REZ25-03 **SW Corner of McKenzie Rd & Windswept Rd, Cook's Corner Partners, LLC** requests favorable recommendation from the Advisory Plan Commission to the Common Council for a petition to rezone approximately 19.65 +/- acres of Cook's Corner Subdivision Section 1 from RM (Residential Moderate) to PUD (Planned Unit Development).

Z:\PLAN COMMISSION\PLAN COMMISSION STAFF REPORTS\2025 PC\REZ25-03 Cook's Corner PUD\REZ25-03 - Cook's Corner PUD - Staff Report.docx

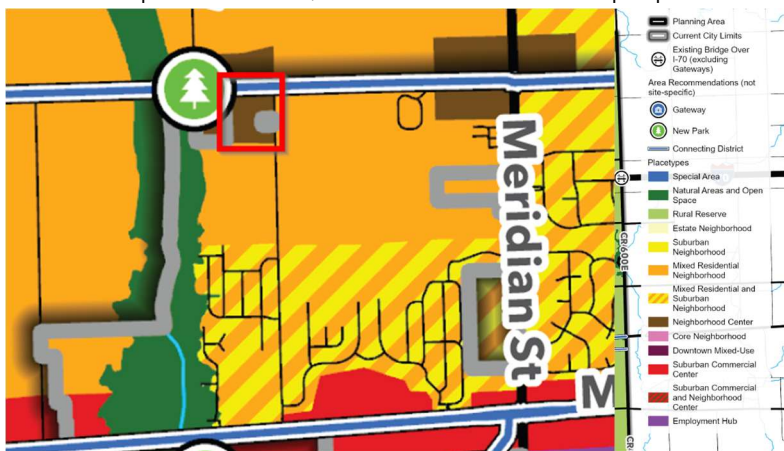
Findings: The Site's intended use is inconsistent with the current Greenfield Comprehensive Plan.

The Future Land Use Map (insert included below) notes this area as Neighborhood Center, which is further described as “a vibrant commercial and civic hub.” This is not in line with the proposed residential-only PUD, though the current zoning is already residential in nature. If we look to the next adjacent district, the Mixed Residential Neighborhood, the proposed PUD and development plan miss much of the intent of that district as well. Of note:

- Pg 80 sites that “new neighborhoods should be developed around focal points like a park or neighborhood center with retail”
 - There is no focal point in this neighborhood
- Defining Features on that same pages mentions that a mix of housing types should accommodate various needs and ensure compatibility with surrounding development
 - The former proposal of paired villas was more in line with this, as they provide a housing option for both starter homes and downsize opportunities.
- Building Design – Character (pg 86) notes that projects should “integrate large windows and porches to engage with the streetscape and encourage interaction between residents and the community”

Given the points above, staff does not find this proposal to be consistent with the Comprehensive Plan.
